Exhibit MB-53

This clipping is from the Sixth Site Plan.

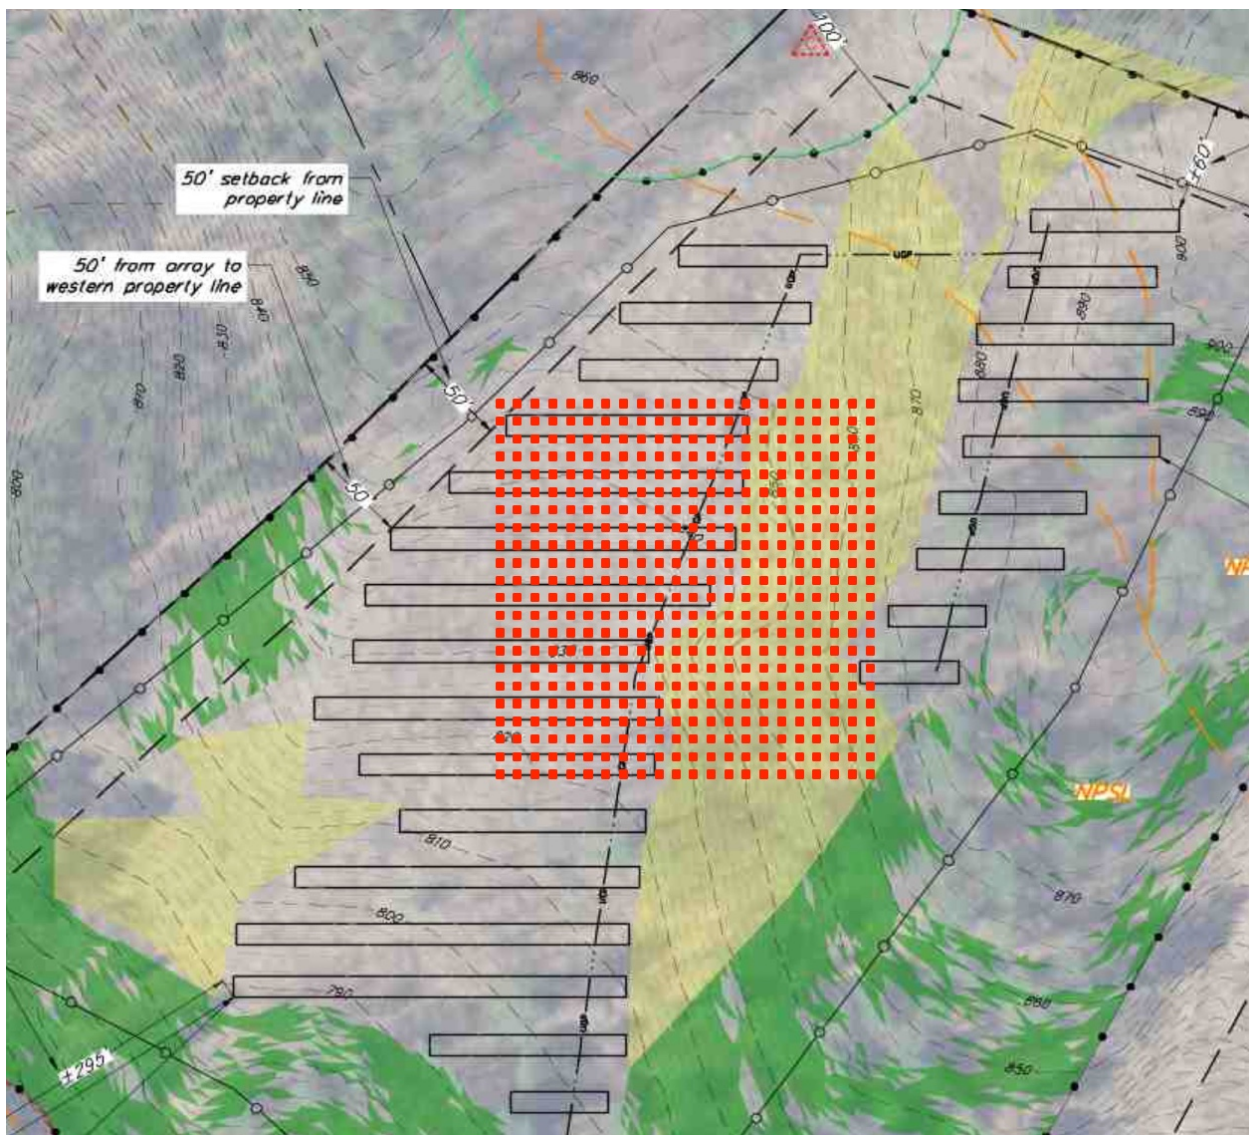
- The 484 points in the illustration below are 10 feet apart and cover an acre.
- A topographic survey of those points would have a 10 foot horizontal resolution.
- LiDAR resolution is much finer than that.
- A topographic survey with 10 foot horizontal resolution requires more than 1800 points to cover 4 acres.
- The ground based topographic survey of this parcel covers about 4 acres with only 76 points.
- 76 data points spread out over 4 acres does not provide adequate resolution to show the steep (greater than 25%) slopes that would be seen on a LiDAR slope layer.
